Technical Service Bulletin

Subject: LIGHT RESISTANCE AND/OR UNUSUAL NOISE WHEN TURNING STEERING WHEEL LEFT OR RIGHT	Bulletin No.: 06-001/21
	Last Issued: 01/20/2021

This bulletin supersedes the previously issued bulletin(s) listed below. The changes are noted in Red text.

[R] Parts (*1) (*2) Location:

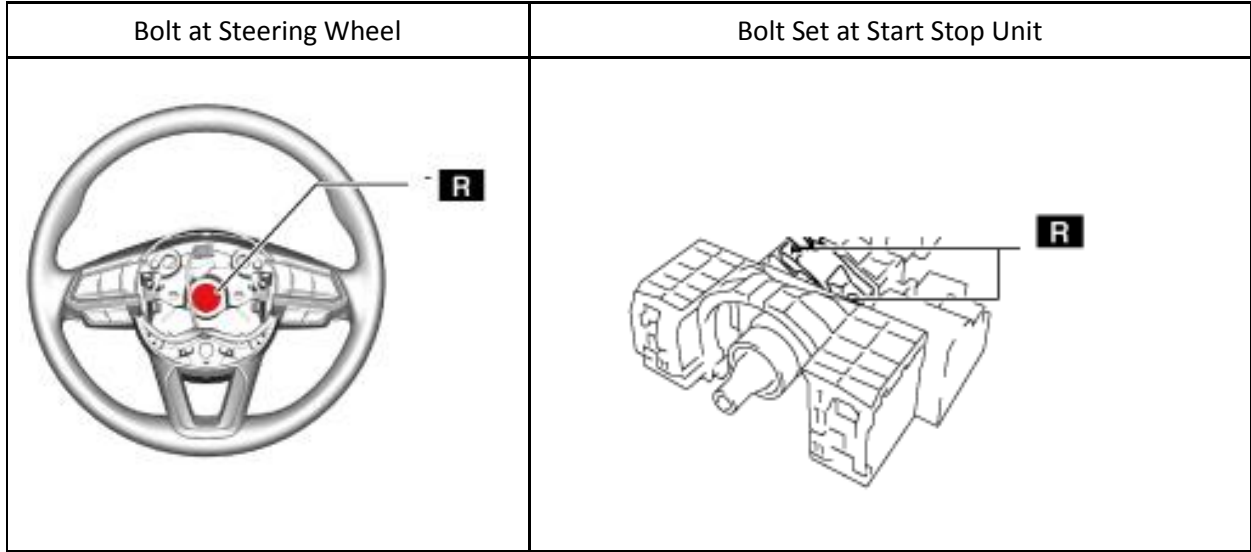
Parts Number	Description	Qty.	Notes
DA7H-32-100N	Shaft, Steering	1	2016-2017 Mazda2
DG7L-32-100F	Shaft, Steering	1	2018-2019 Mazda2
DHM1-32-100A	Shaft, Steering	1	2020 Mazda2
DB4G-32-100K	Shaft, Steering	1	2016-2017 CX-3
DH1E-32-100D	Shaft, Steering	1	2018-2019 CX-3
DM6F-32-100C	Shaft, Steering	1	2020 CX-3
B455-32-099B	Shaft, Bolt	1	[R]
D10J-32-099	Shaft, Bolt	1	[R]
9YA0-11-003A	Bolt	1	[R] (*1)
KA01-66-154	Bolt, Set	2	[R] (*2)
